# 1981 Corvette: Service Bulletin: Glow Around Wiper Switch Rework Wiper Switch Bezel

**Model and Year:** 1981 Corvette

**Bulletin Number:** 81-I-19

**Date:** January 1981

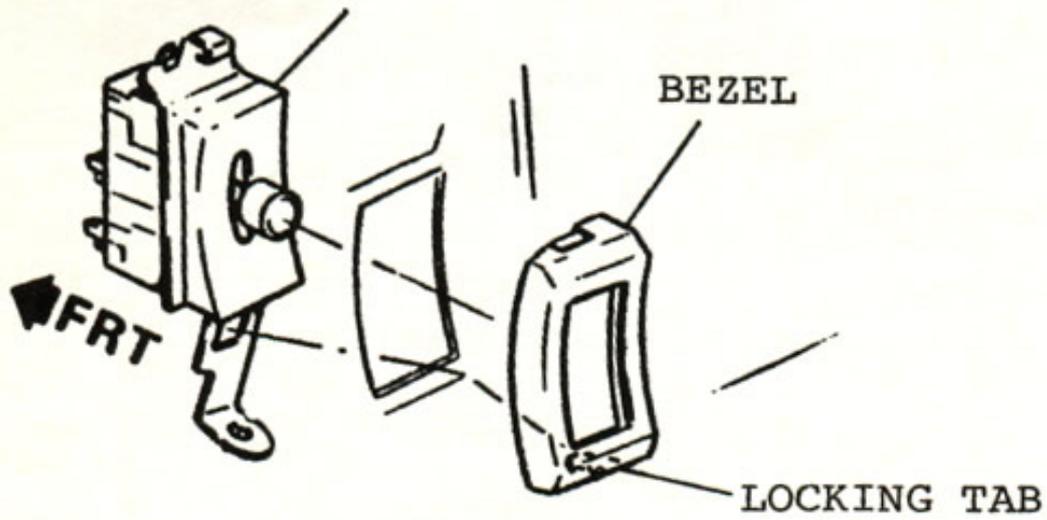
SOME EARLY 1981 CORVETTES WITH SILVER, RED, OR RUST TRIM MAY EXHIBIT A GLOW AT NIGHT AROUND THE WIPER SWITCH BEZEL. IN THESE COLORS, THE BEZEL BASE MATERIAL IS "NATURAL" AND COULD BECOME TRANSLUCENT WITH LIGHTS TURNED ON. THE REMAINING BEZEL COLORS WERE PAINTED OVER A BLACK BASE MATERIAL AND ARE NOT AFFECTED.

THE GLOWING CONDITION CAN BE ELIMINATED BY REPLACING THE ORIGINAL BEZEL WITH P/N 14016216, WHICH IS BLACK AND MUST BE PAINTED TO MATCH TRIM COLOR. THE BEZEL HAS A LOCKING TAB WHICH ENGAGES THE WIPER SWITCH AS ILLUSTRATED ON PAGE 2.

CORVETTE WIPER SWITCH BEZEL ATTACHMENT

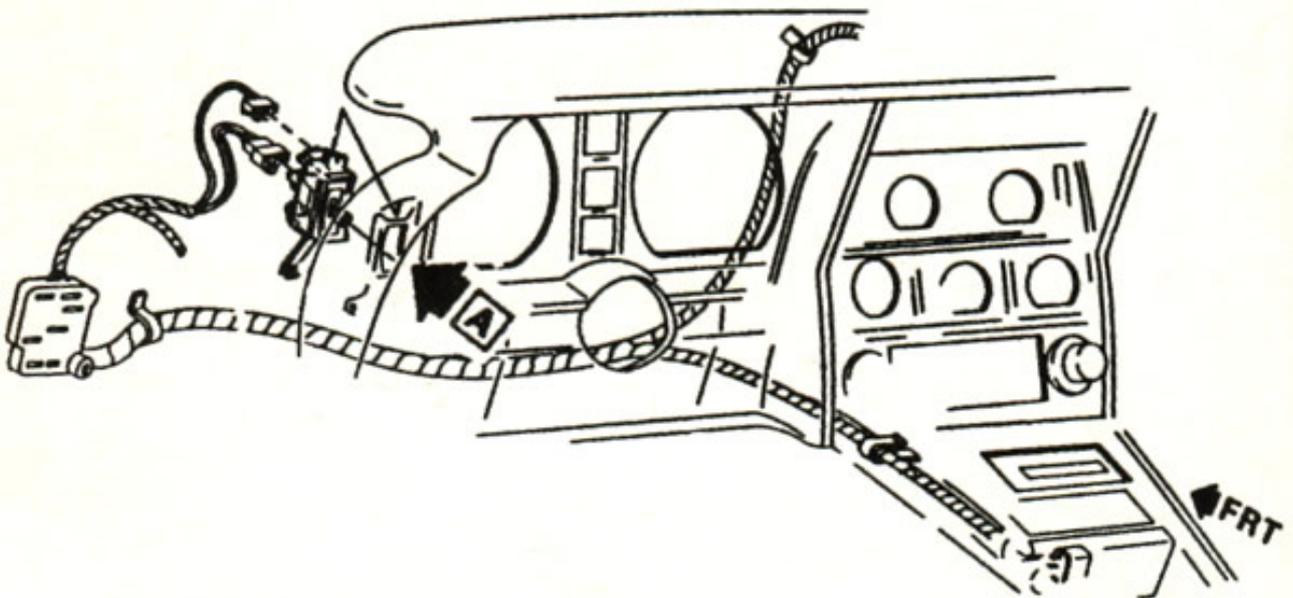
REPLACEMENT REQUIRES SETTING THE STEERING COLUMN TO ITS LOWEST TILT POSITION, REMOVING THE SPEEDOMETER CLUSTER, AND REACHING THROUGH THE INSTRUMENT PANEL TO DISCONNECT THE BEZEL LOCKING TAB.
